Addendum #: Addendum #5
Issue Date: 04/19/2024

The following additions, clarifications and revisions have been made to the Contract Documents:

EDGAR COUNTY, ILLINOIS EDGAR COUNTY PUBLIC SAFETY CENTER

A130

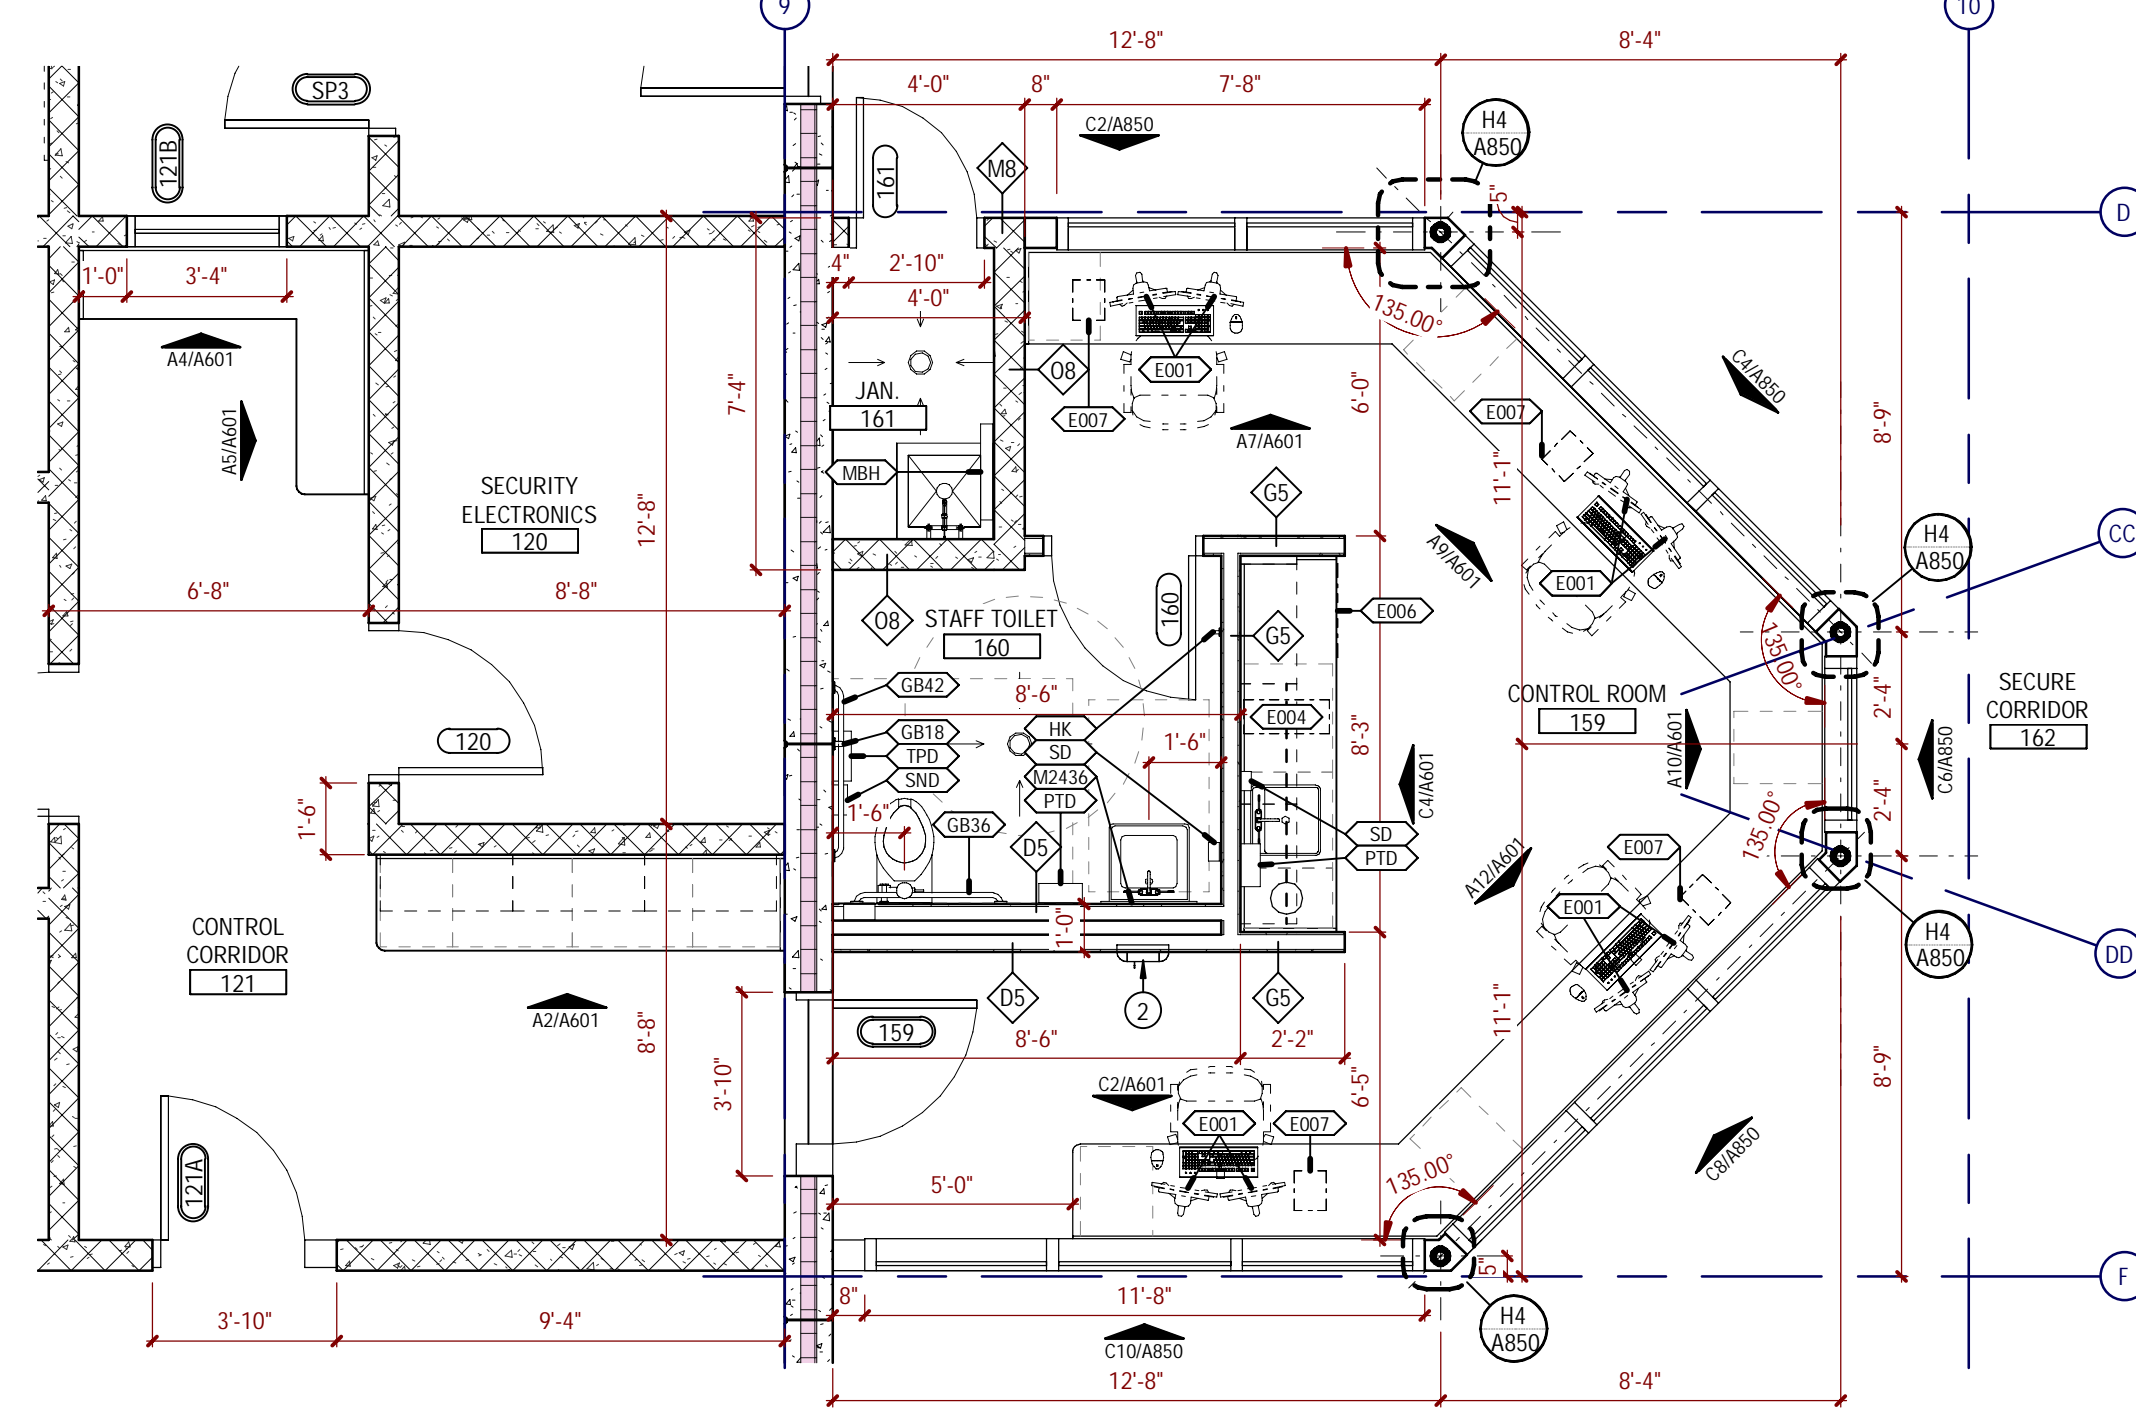
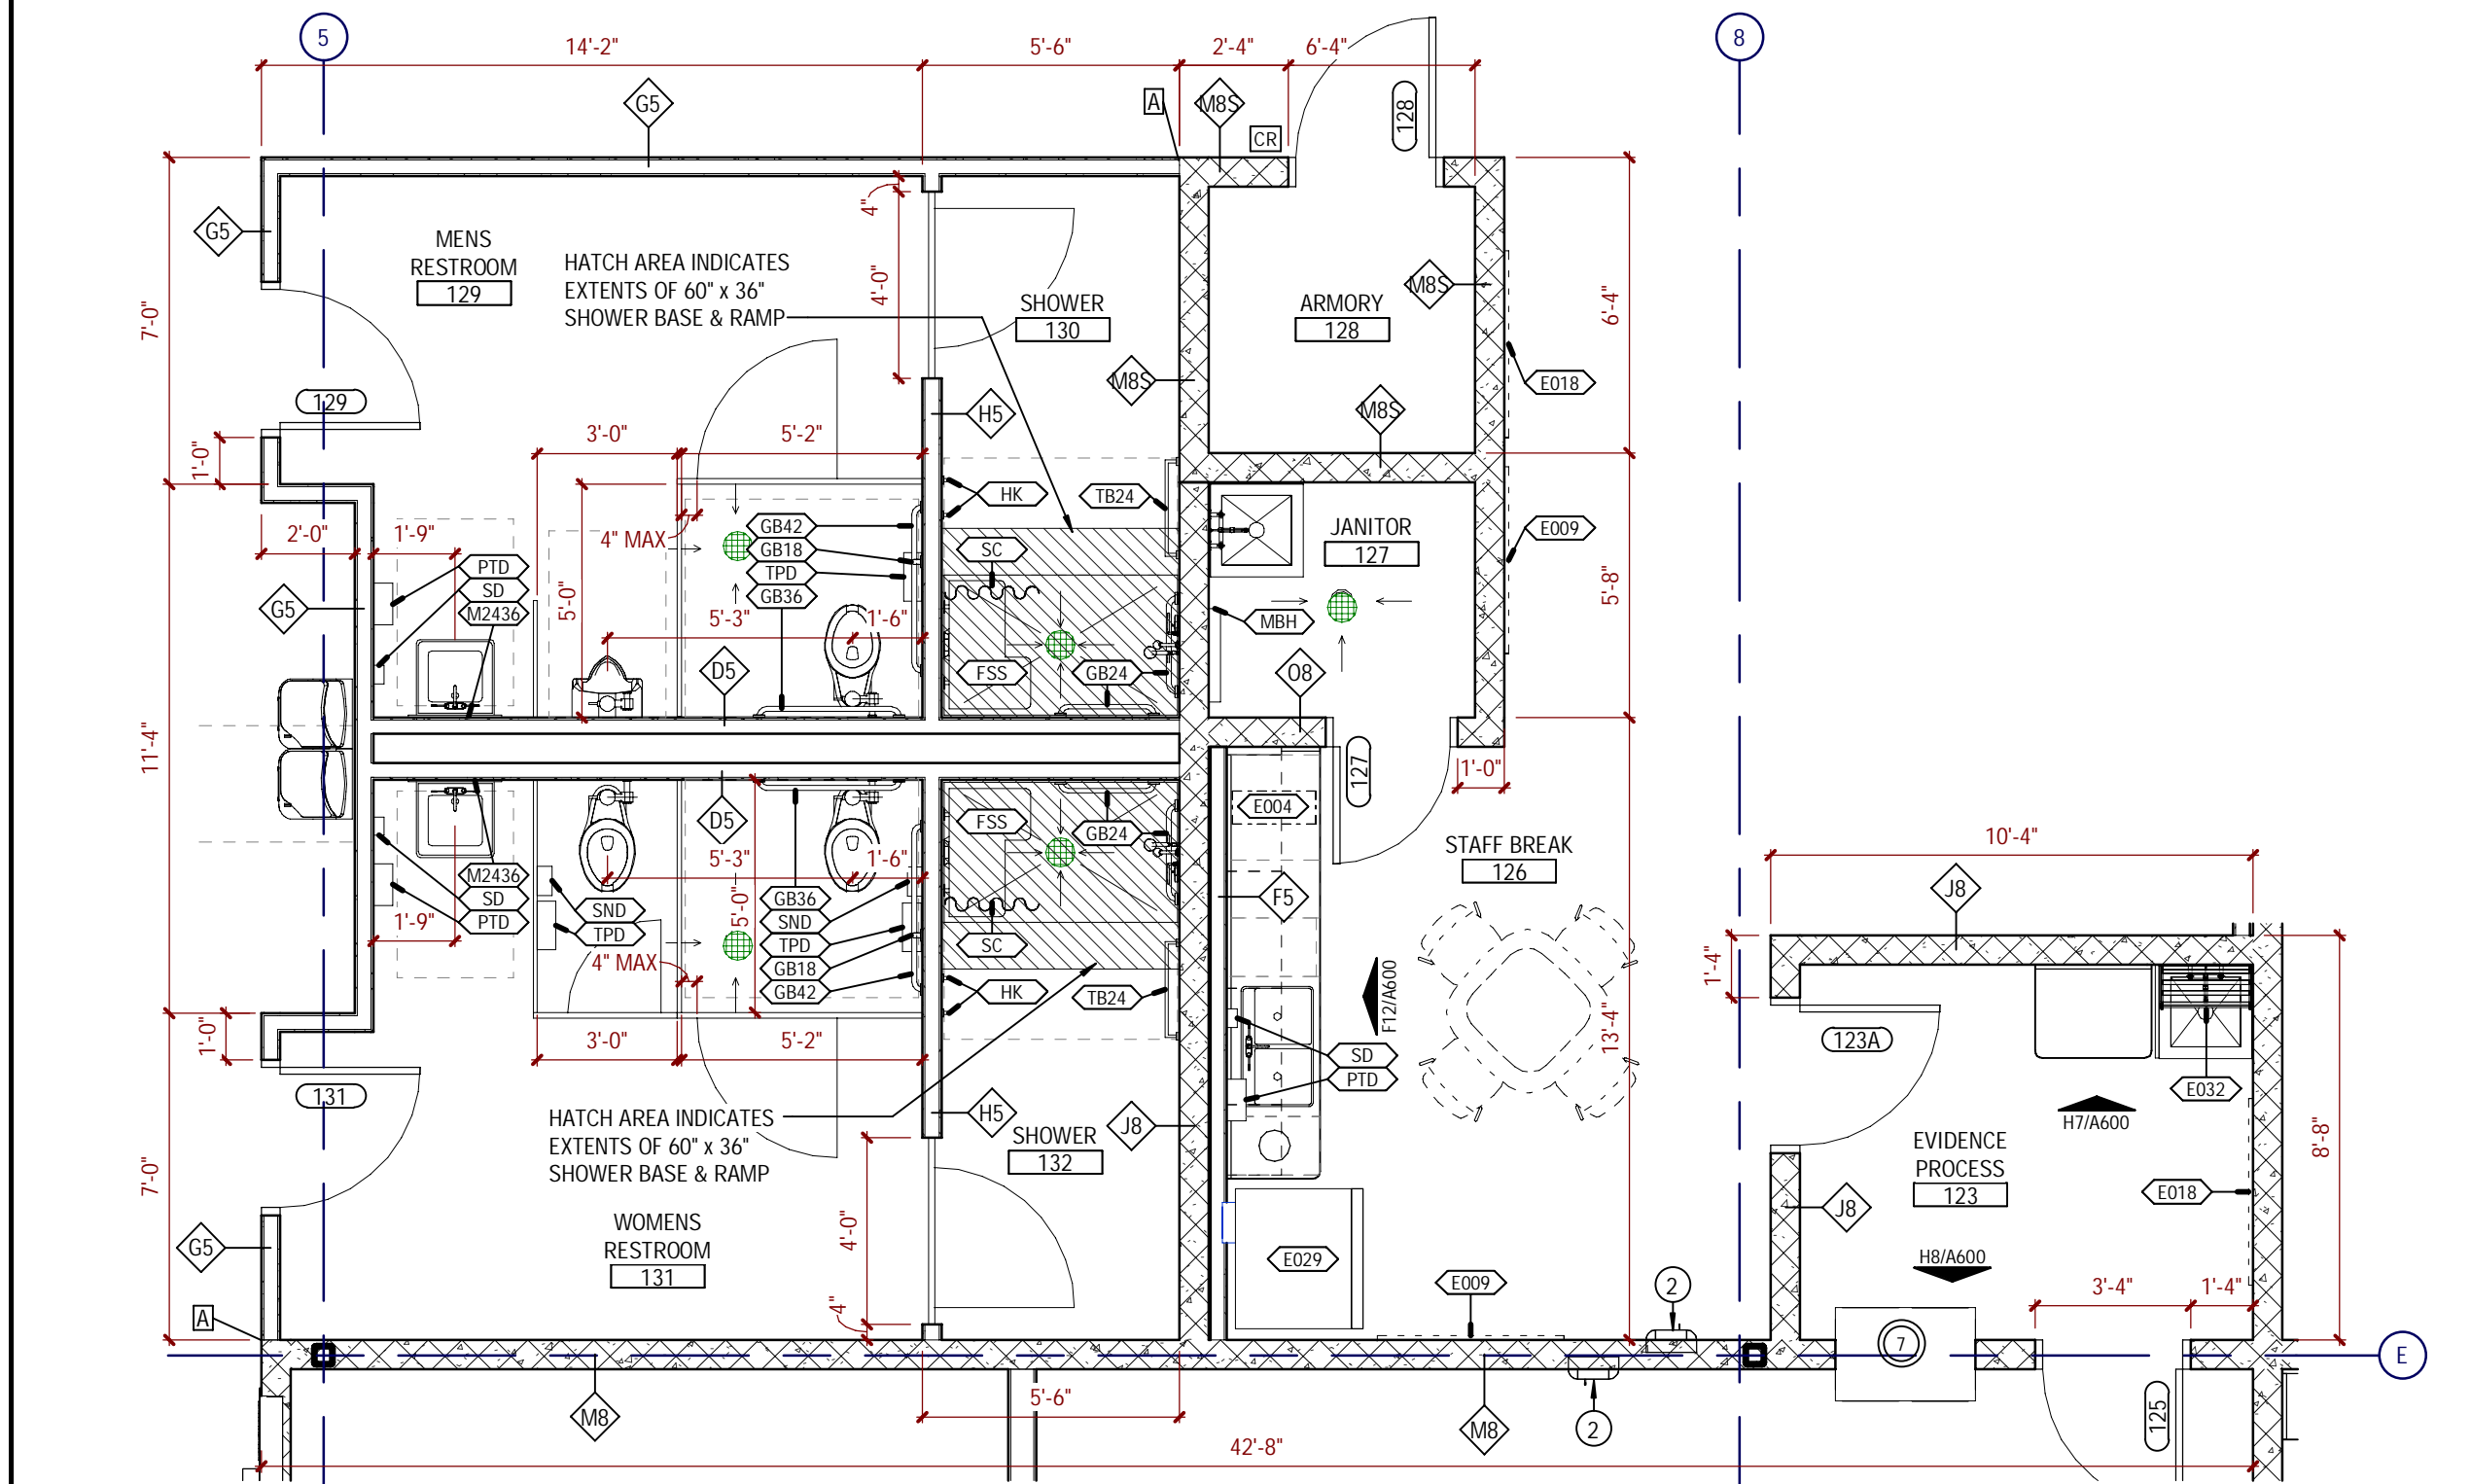
- 1) *Provide items on detention equipment schedule per sheet A130*
 - ~~a.a)~~ *Provide stainless steel drawer and cabinet at package pass per A530/F5 and equipment schedule item E020 on A600*

A:	Amanda Springer (Klingner & Associates, P.C) Responded Fri Apr 19, 2024 at 09:14 am CDT CLARIFY: The floor slab should be flat at the Onyx shower pans and at the ramp (shown by hatch pattern on sheet A130). Beyond these extents, slope floor per structural to the floor drains near toilets. ADD 5
